# TECHNICAL BULLETIN

**[Issue No.]** FA-A-0048

**[Title]** No +24V input wiring required on the general-purpose I/O terminal block of the AJ65BT-R2N CC-Link system RS-232 interface module

**[Relevant Models]** AJ65BT-R2N

## (External wiring diagrams for general-purpose output)

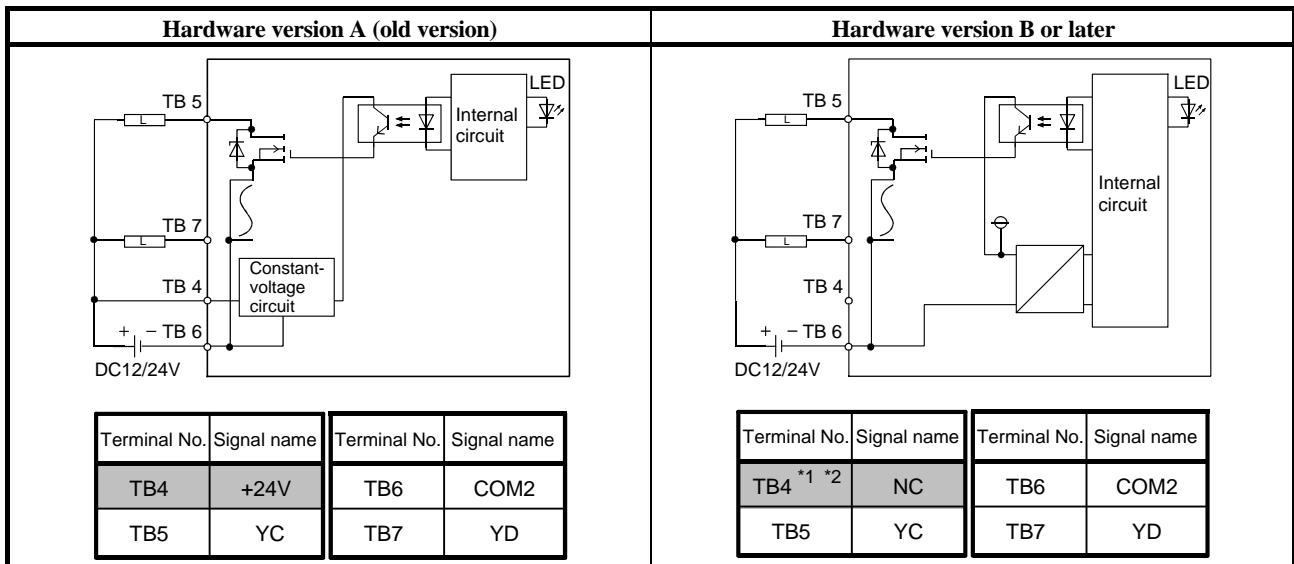
For the AJ65BT-R2N of hardware version B or later, the +24V input wiring on the general-purpose I/O terminal block is not required.

\*1 An input of +24V is allowed, just like in hardware version A (old version).

The existing wiring can be used when replacing hardware version A with hardware version B or later.

\*2 No +24V input wiring is required, just like in the case of the AJ65BT-R2.

The existing wiring can be used when replacing the AJ65BT-R2 with the AJ65BT-R2N.

### 2 Checking the hardware version of the module

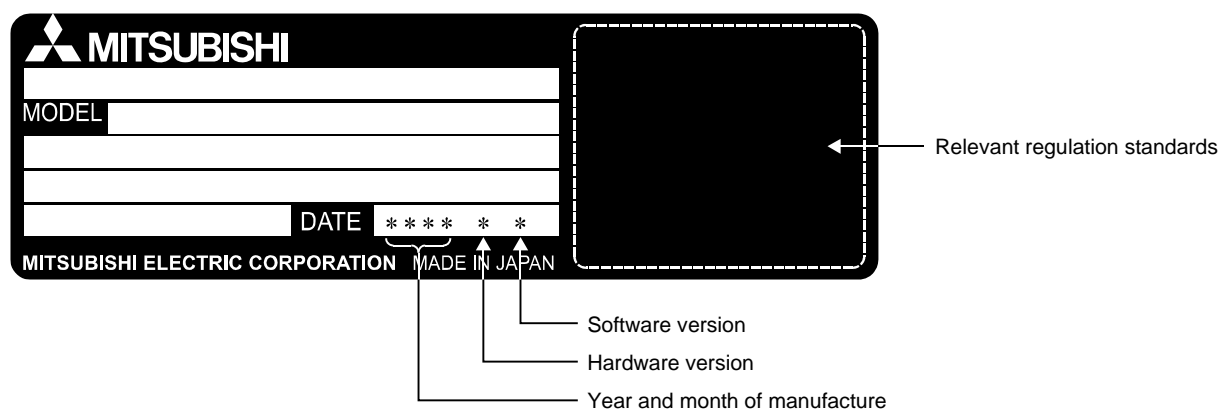
The changes apply to the AJ65BT-R2N hardware version B or later.

The hardware version of the AJ65BT-R2N can be checked in the DATE section on the rating plate.
